# CITY OF ALBUQUERQUE

**Re: Village at Avalon, 601 90<sup>th</sup> St. NW Buildings 1, 2, 3, 9, & 10**  
**Request for Certificate of Occupancy**  
**Transportation Development Final Inspection**  
Engineer's Stamp dated 4-8-16 (K09D040)  
Certification dated 2-20-18

RE: Village at Avalon  
601 90<sup>th</sup> Street NW  
Zone: SU-2 for R2 Uses  
Submittal: TCL for Final C.O. of Phase 3

## SDP-1.1

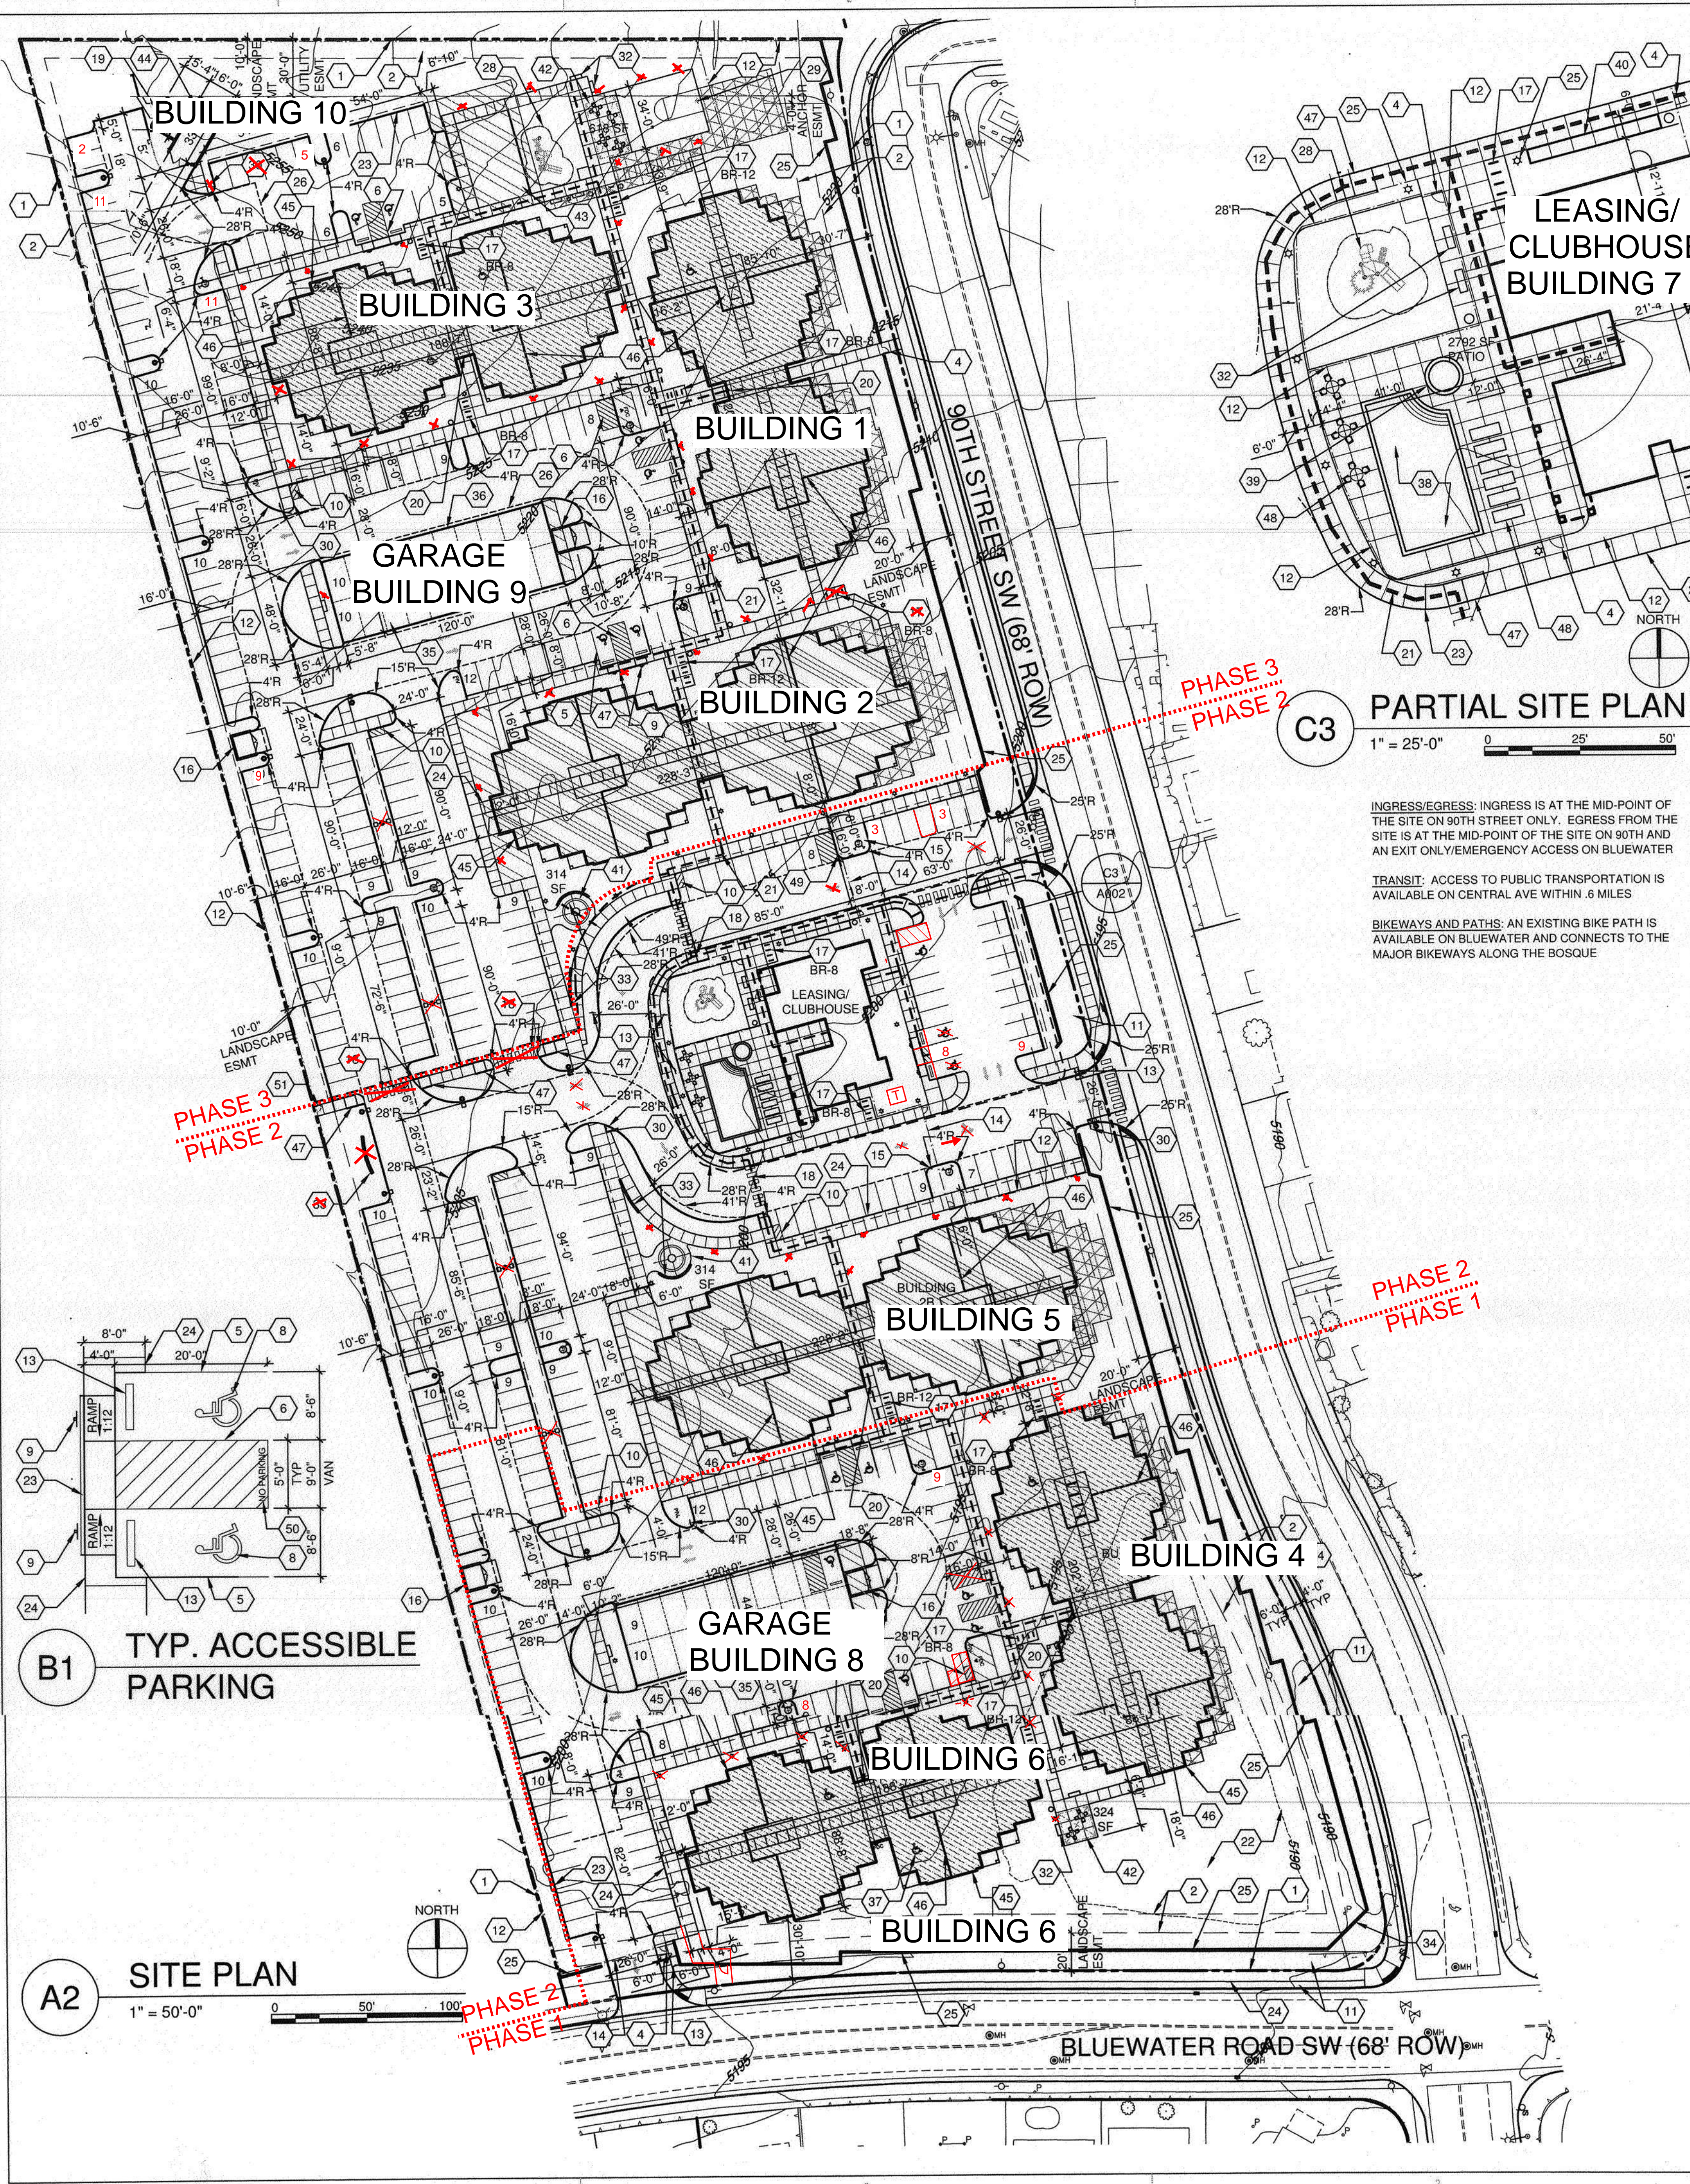
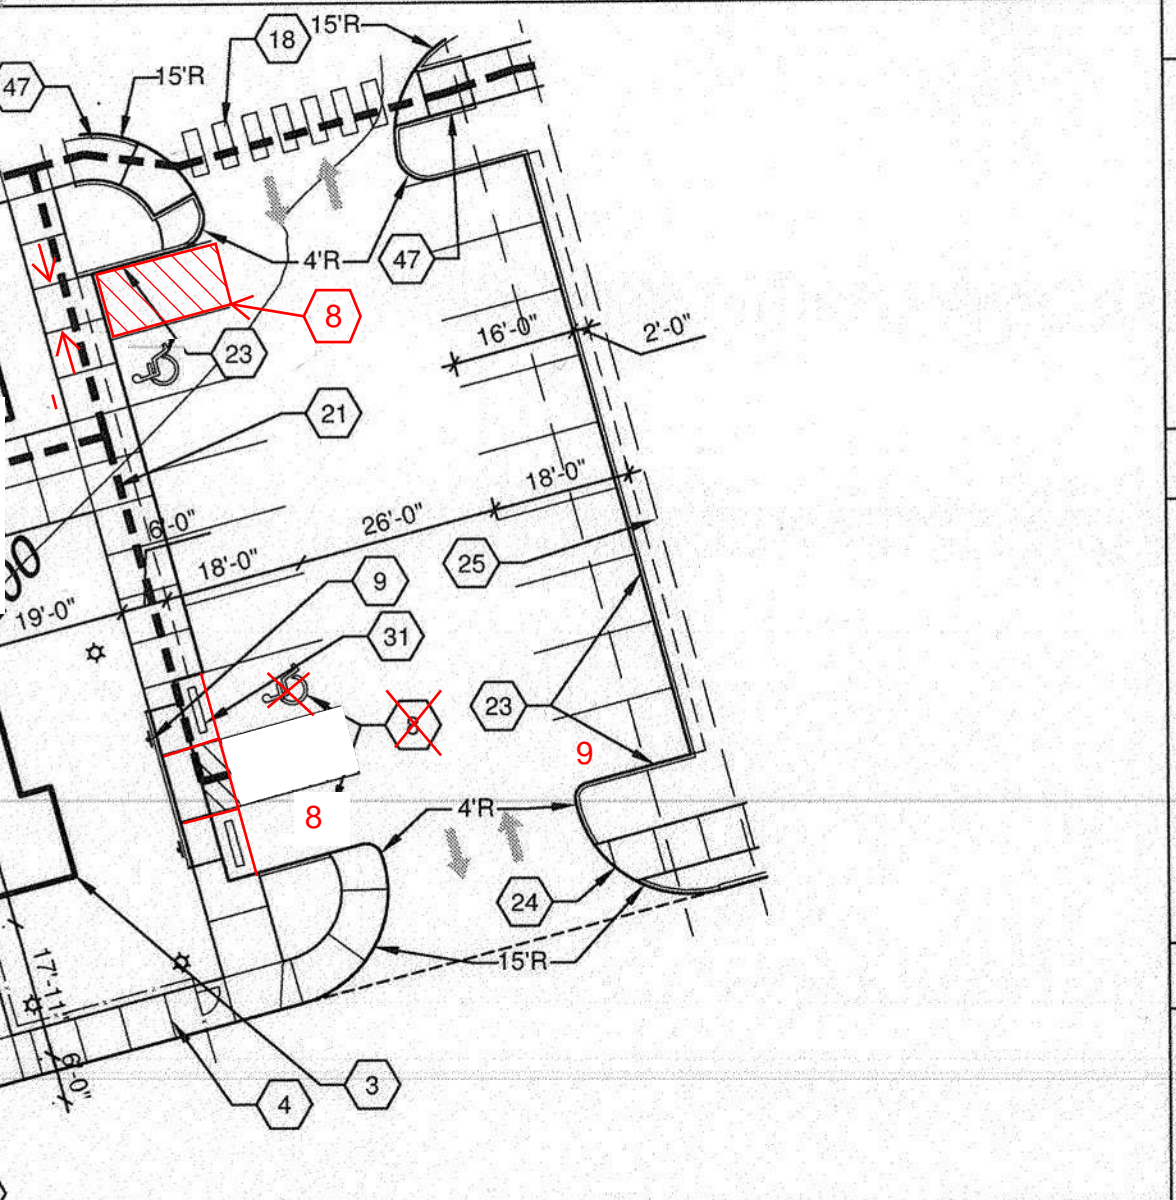
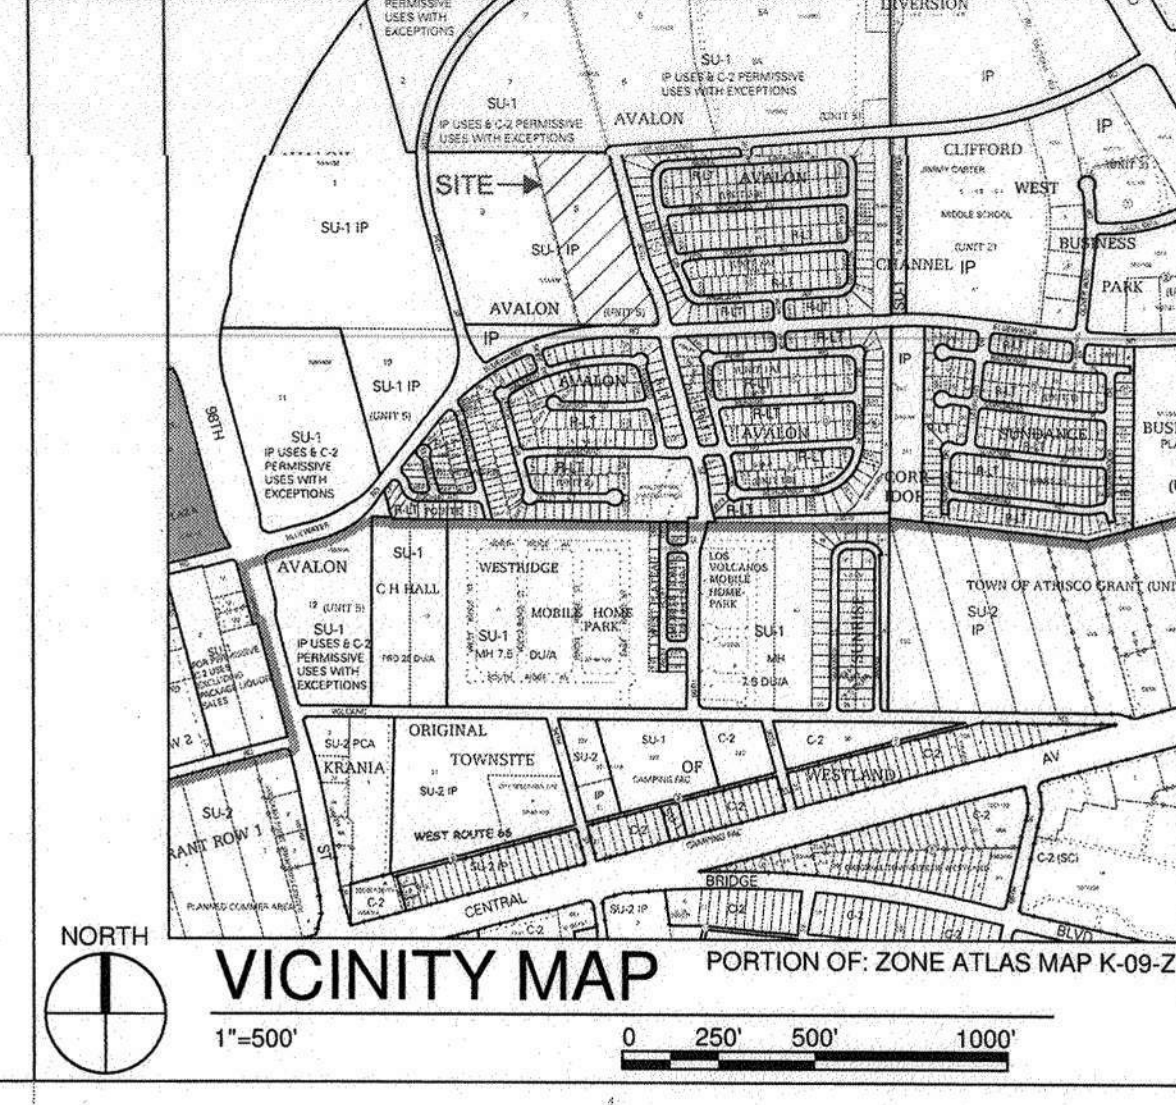
- Changes to the site such as the removal of painted cross walk and site lighting changes require an approval administrative amendment.
- All stop signs must be constructed per the plan prior to the final CO.

- Bike rack north of Building 3 not installed yet, contractor to install.
- Painted pedestrian crosswalk internal to site have been removed from plan where noted.
- Stop sign internal to site has been removed from plan where noted.
- Site lighting is primarily achieved through wall packs on the buildings and pedestrian pole lights shown on the SDP were eliminated.
